TOWN OF PORTOLA VALLEY
REGULAR PLANNING COMMISSION MEETING
765 Portola Road, Portola Valley, CA 94028
Wednesday, October 16, 2013 – 7:30 p.m.
Council Chambers (Historic Schoolhouse)

TO: Planning Commission
FROM: Tom Vlastic, Town Planner
DATE: October 11, 2013
RE: Agenda for October 16, 2013 Planning Commission Meeting

Site Development Permit X9H-656, 5 Naranja Way, Maffia

**Proposed
Landscape Plan**

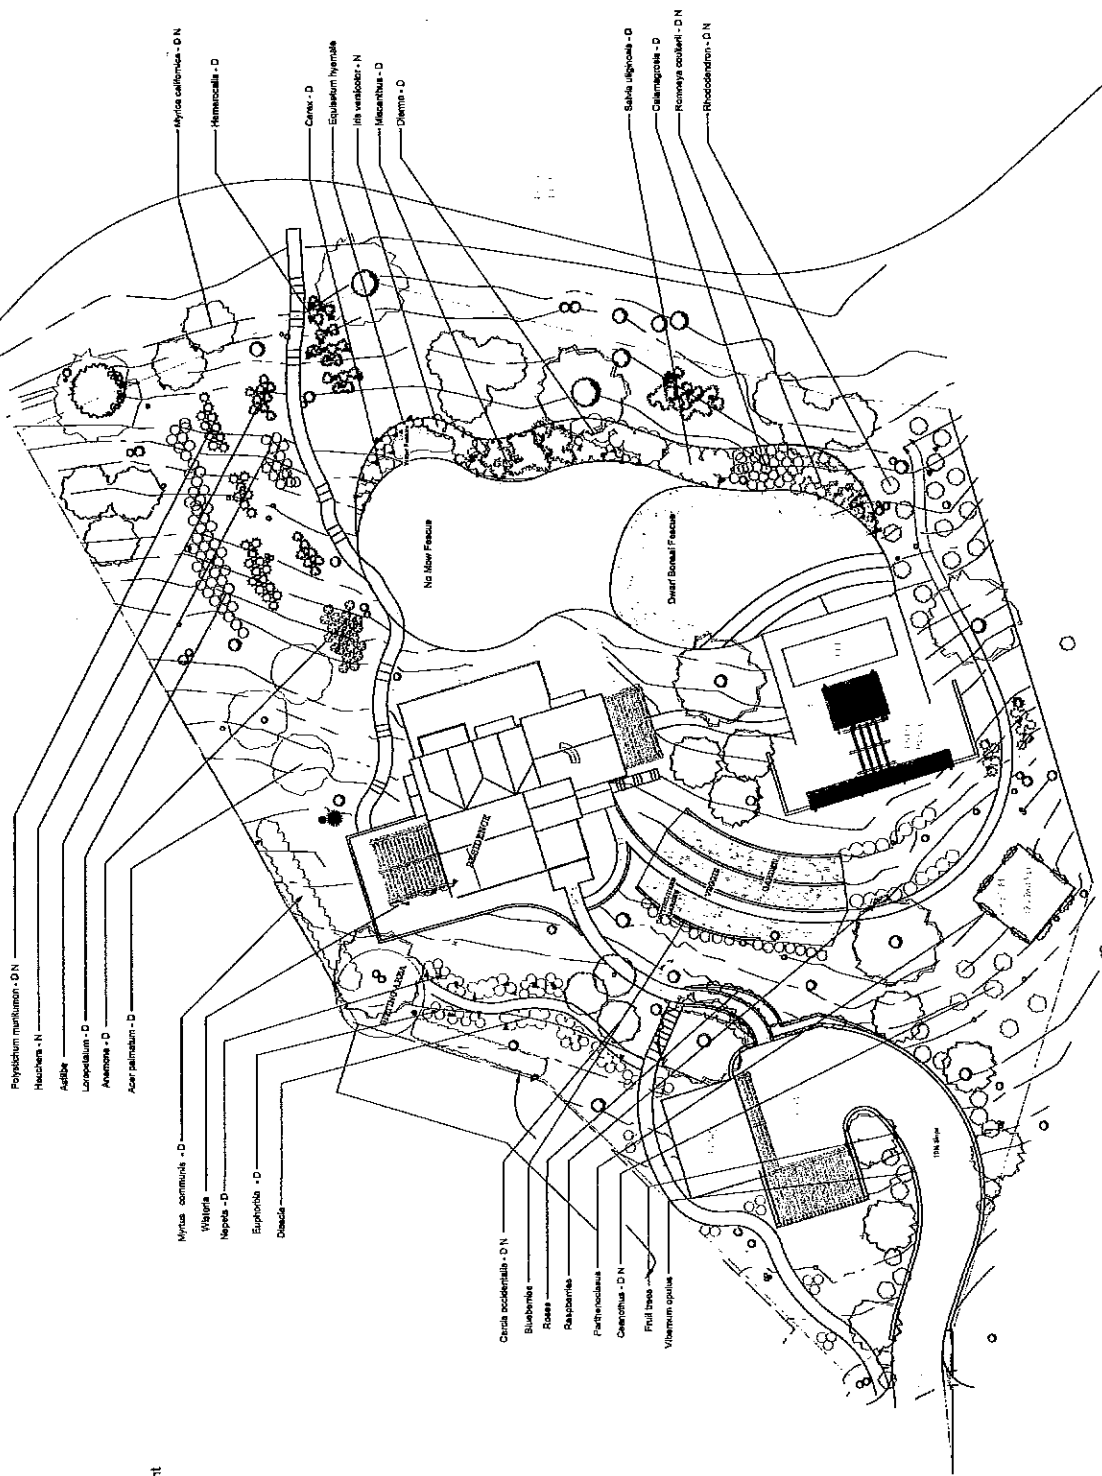
6. **Landscaping/fencing.** The plans do not identify any new fencing with the project. If any is planned it should be identified to the satisfaction of the ASCC. The concepts for landscaping are presented on Sheet A2.3. The approach and plant selection appear generally consistent with town guidelines. The site meeting, however, will provide the opportunity for the landscape concepts to be fully presented to the ASCC. Our two main preliminary comments are that there appears to be the need for some additional screen planting along the west and south sides of the garage/parking area and that every effort should be made to save and reuse the existing rock and stone pathways.

A2.5
 SHEET

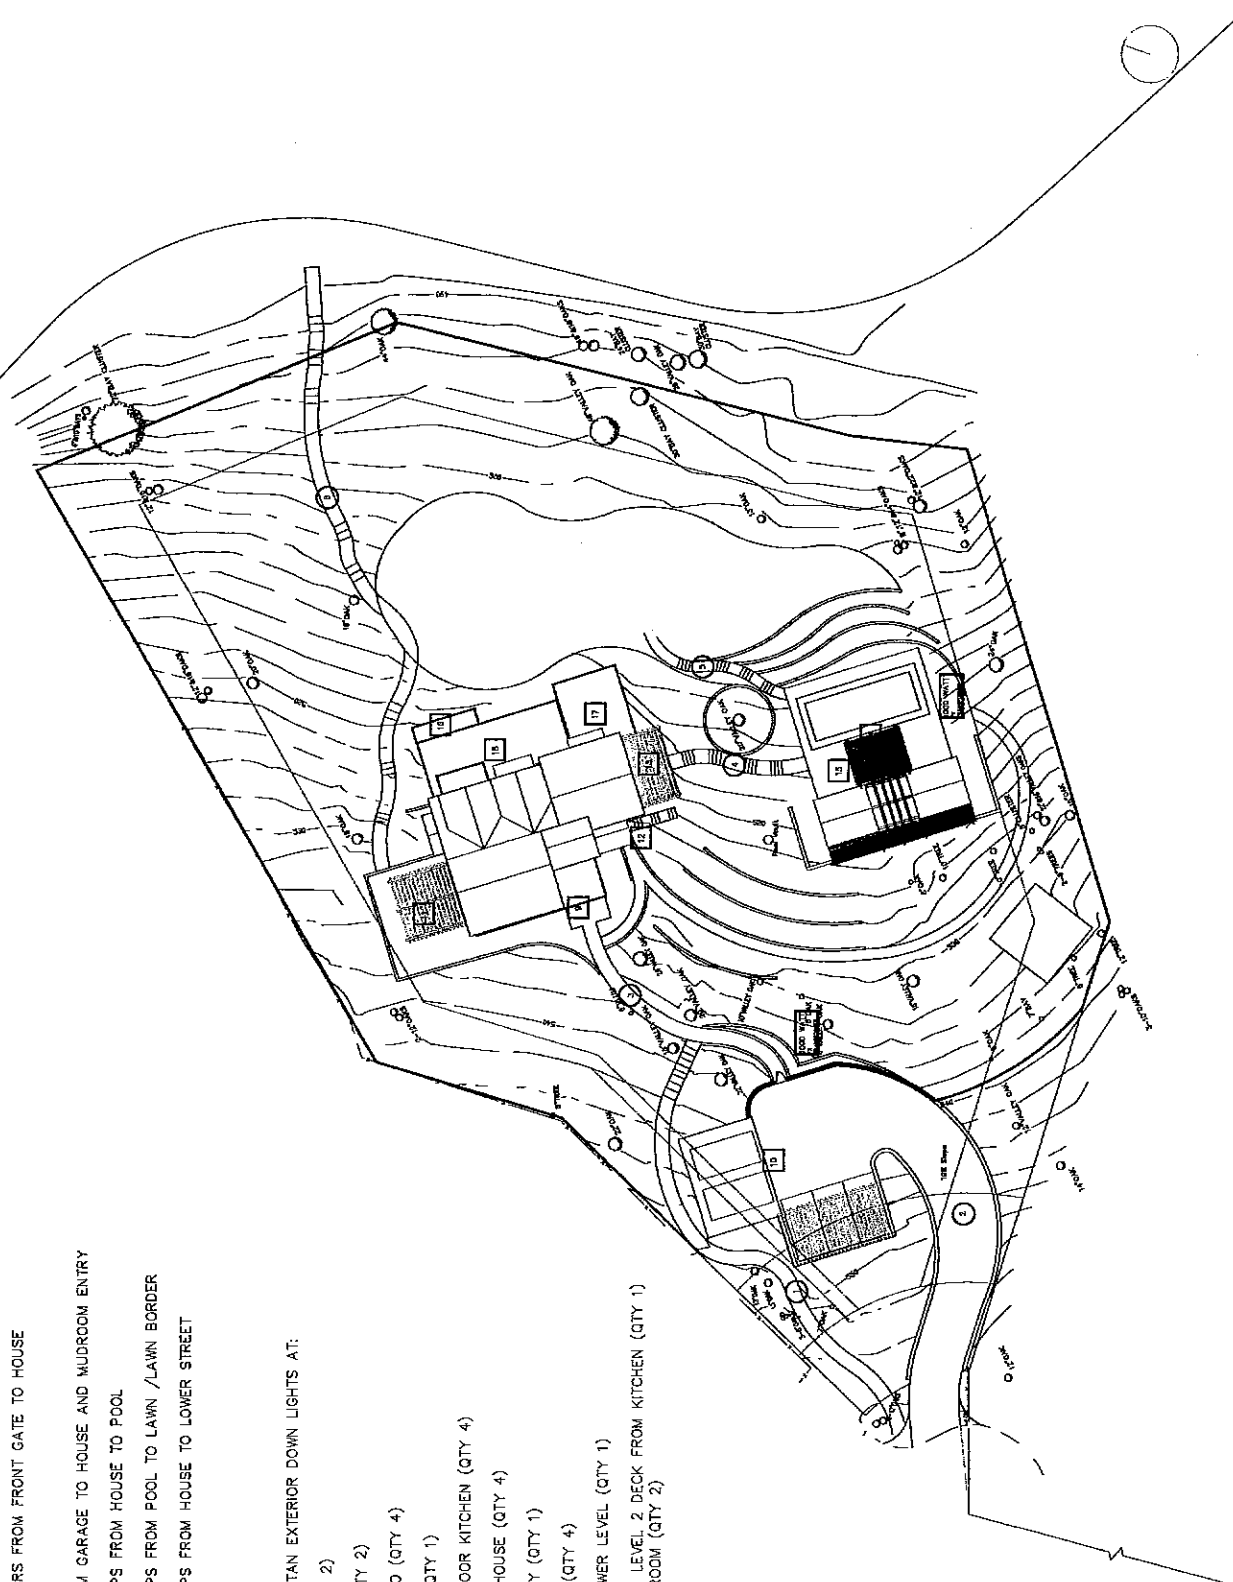
7. **Exterior Lighting.** The concepts for lighting are shown on plan Sheet A2.5 and fixture cut sheets are attached. The details for fixture placement need to eventually be defined to the satisfaction of the ASCC. The concepts should be discussed with the design team at the evening 10/14 ASCC meeting.

A2.13
 SHEET

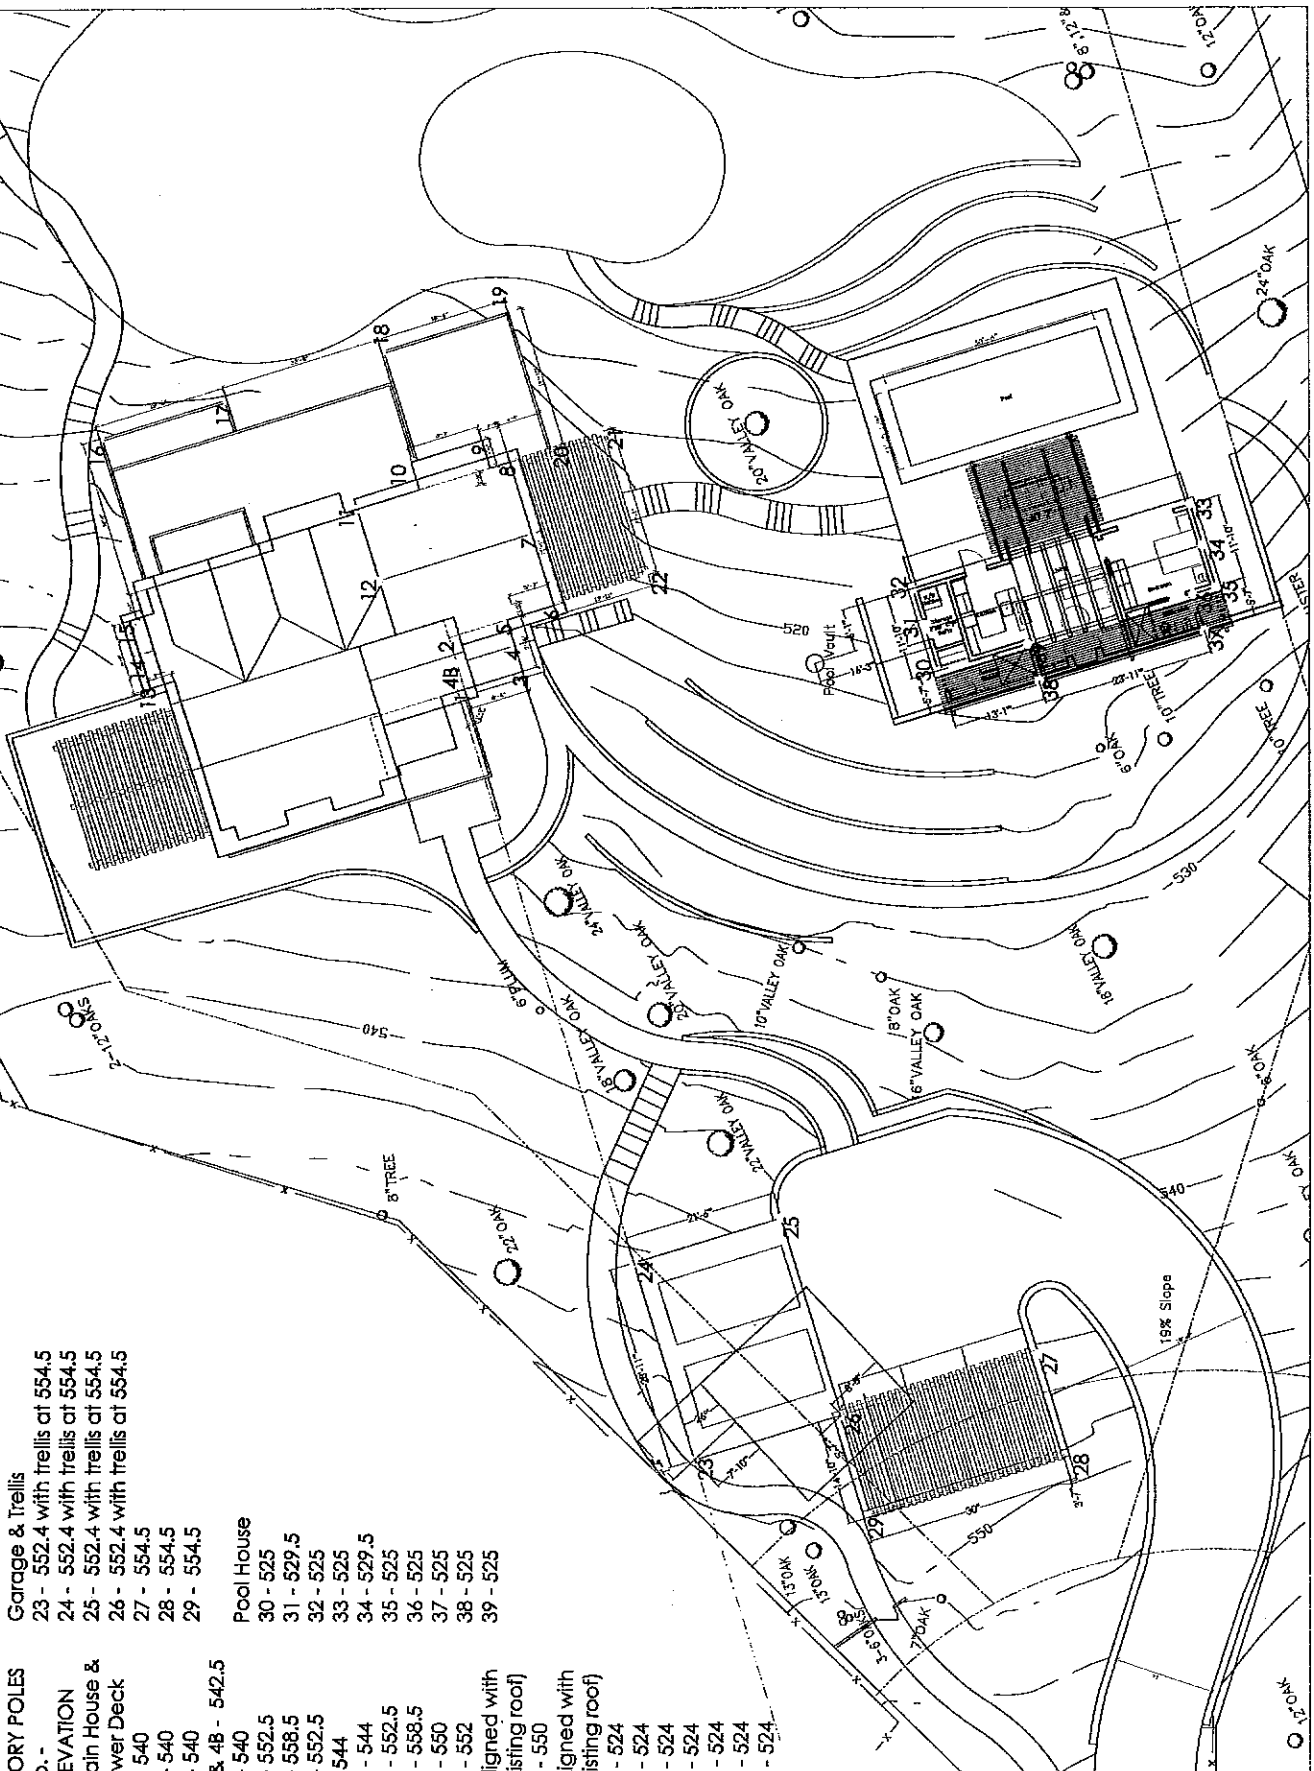
As noted at the head of this memorandum, the preliminary review process is to begin with a 4:00 p.m. site meeting on Monday October 14th 2013. To facilitate the site meeting, story poles have been set at the property to model the project as noted on enclosed plan Sheet A2.13.

**Existing
Exterior
Elevations**

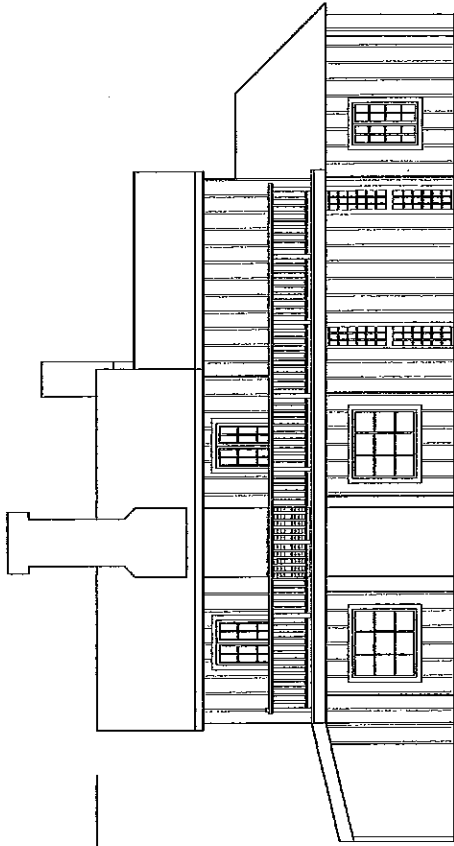
to be consistent with the historic character, but already achieve a height over adjacent grade of over 35 feet (Sheet A3.1). Thus, the proposed expansion with a roof form consistent with the historic architecture increases the height by roughly 2.5 feet over the existing condition. Without the variance the third floor expansion could not occur making use of the historic roof form.
